## 2.15 Structures and Servicing Systems

The information in this section of the reference ABWR DCD, including all subsections, tables, and figures, as modified by the STP Nuclear Operating Company Application to Amend the Design Certification rule for the U.S. Advanced Boiling Water Reactor (ABWR), "ABWR STP Aircraft Impact Assessment (AIA) Amendment Revision 3," dated September 23, 2010 is incorporated by reference with the following departures.

Table 2.15.5c Reactor Building Safety-Related Equipment HVAC System

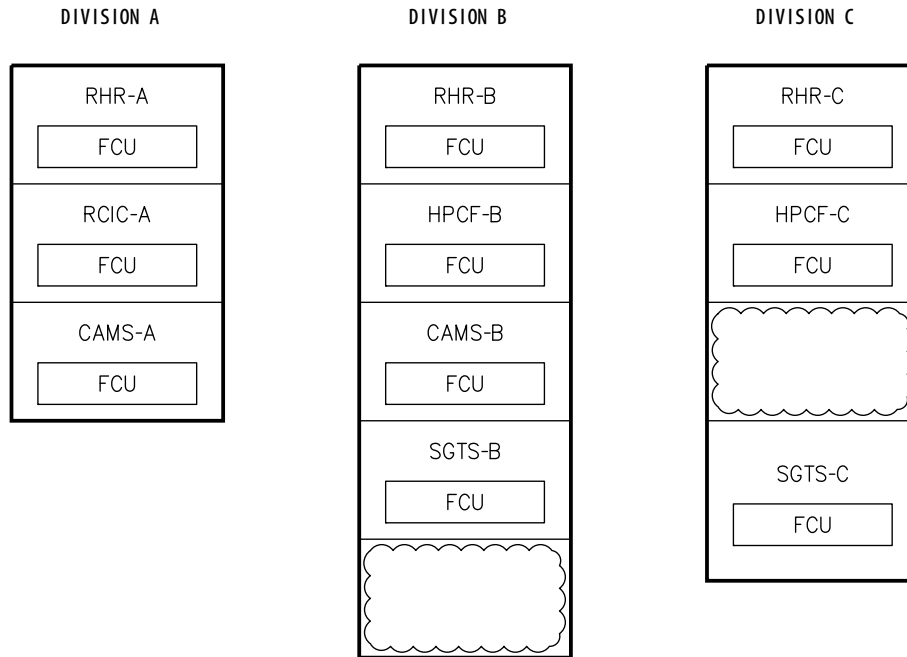
STD DEP T1 2.14-1 (Figure 2.15.10a, Figure 2.15.10j, Figure 2.15.5e, Table 2.15.5c)

Inspections, Tests, Analyses and Acceptance Criteria		
Design Commitment	Inspections, Tests, Analyses	Acceptance Criteria
<del>4. The FGS room FCUs are initiated upon a manual FGS start signal. Not used.</del>	<del>4. Tests will be conducted on each as built FGS room FCU using a simulated initiation signal. Not used.</del>	<del>4. The FGS room FCU starts upon receipt of a signal indicating FGS start. Not used.</del>

**Figure 2.15.5e Reactor Building Safety-Related Equipment HVAC System**

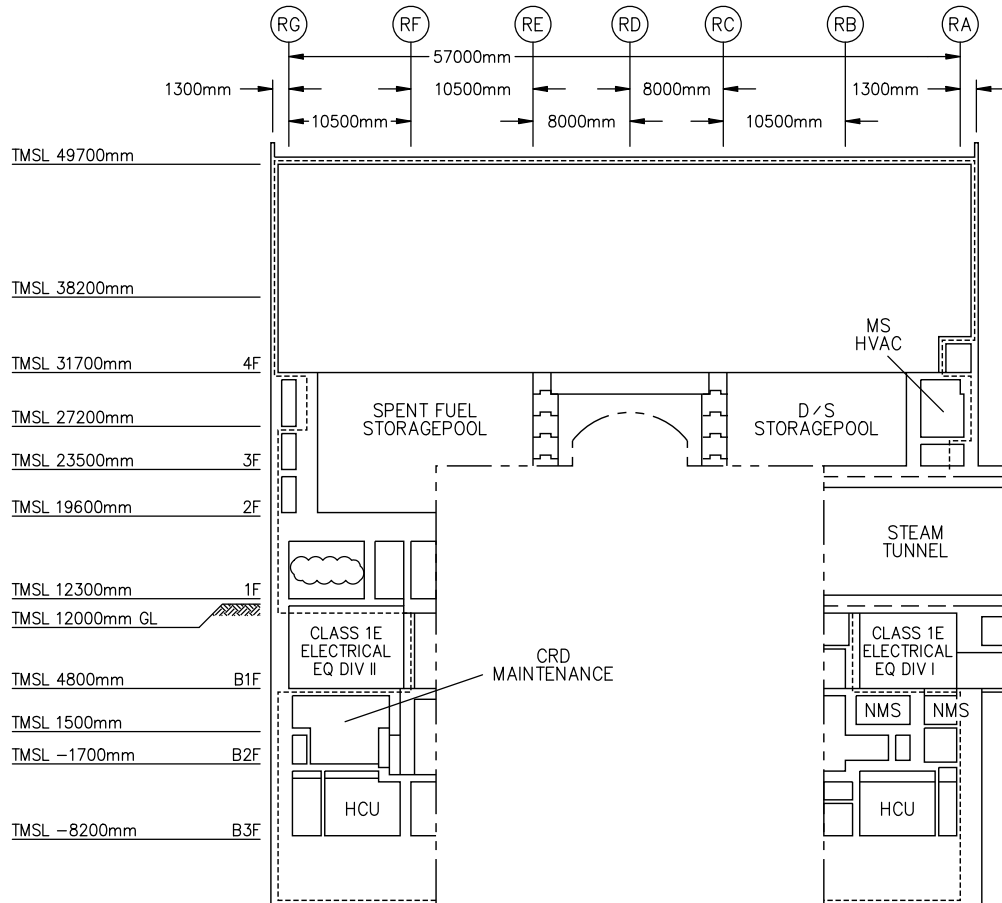
*The R/B Safety-Related Equipment HVAC System provides cooling of safety-related equipment areas, and consists of independent fan coil units. Figure 2.15.5e shows the basic system configuration and scope.*

*The Residual Heat Removal (RHR) System, High Pressure Core Flooder (HPCF) System and Reactor Core Isolation Cooling (RCIC) System pump room FCUs are automatically initiated upon startup of their respective room process pump. The Containment Atmospheric Monitoring System (CAMS) and Standby Gas Treatment System (SGTS) room FCUs are automatically initiated upon isolation of the Reactor Building Secondary Containment HVAC System. ~~The Flammability Control System (FCS) room FCUs are also initiated upon a manual FCS start signal.~~*

Figure 2.15.12a Control Building Arrangement, Section A-A

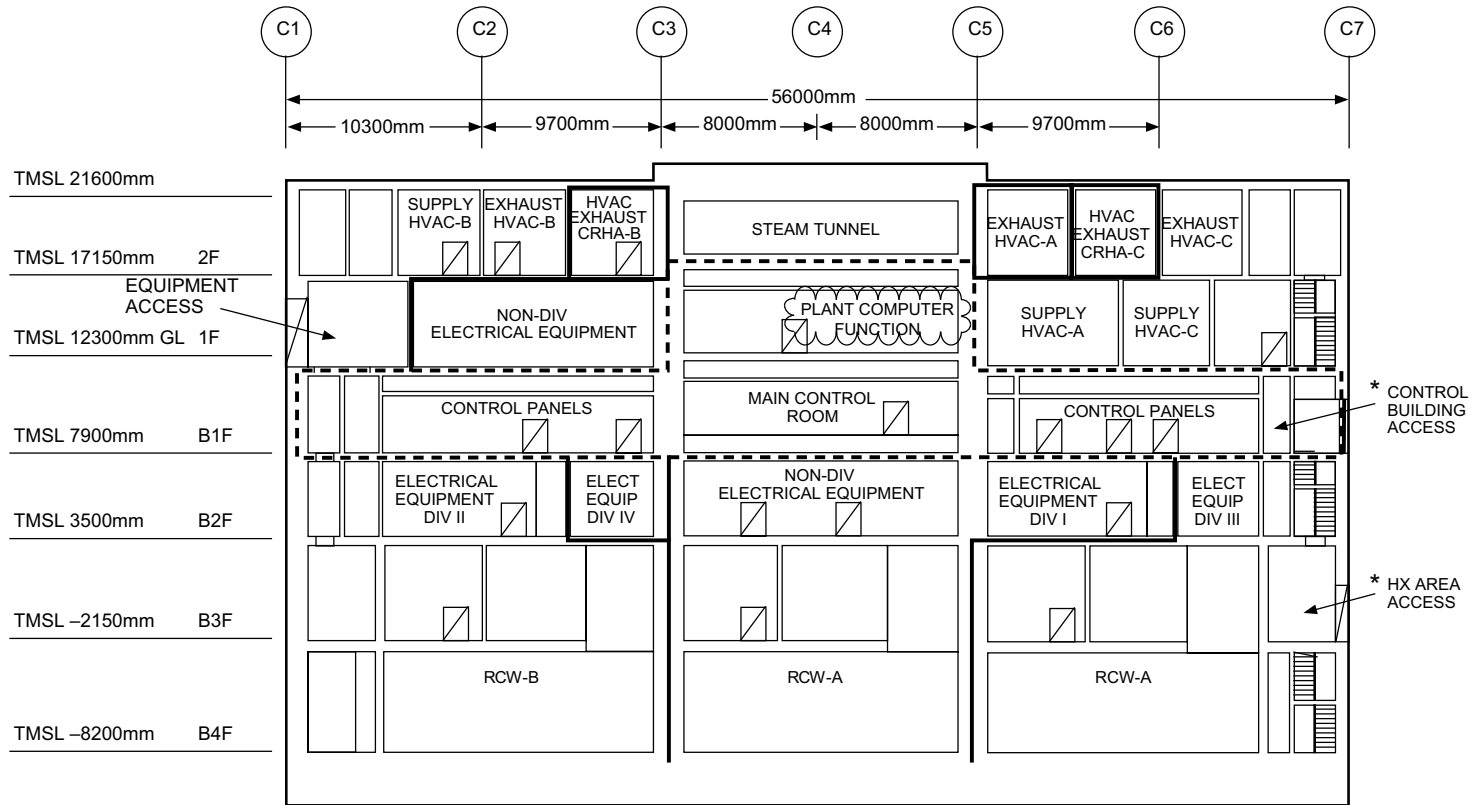
STD DEP T1 3.4-1 (Figure 2.15.12a, Figure 2.15.12b, Figure 2.15.12g)
